Access audit at West Dene Family Centre, Birch Road, Pendlebury

Conducted on 6th August 2013

Introduction: Access 2 All Areas were asked to conduct an audit of West Dene Family Centre by Russ Nutter of the City Council's asset management team. The premises at West Dene are all on ground level so this is better for visitors with mobility issues.

Entrance to one of the contact areas

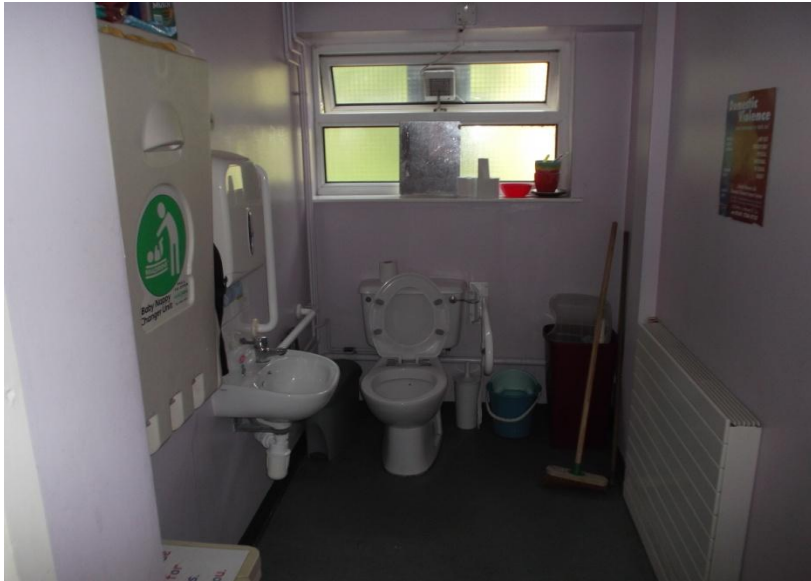
The contact areas were all accessible to disabled people with enough width between the door frames. Seating was provided in all of the rooms, particularly for children who use the facilities. The furniture had rounded edges (in the main) with very few sharp edges except for tables.
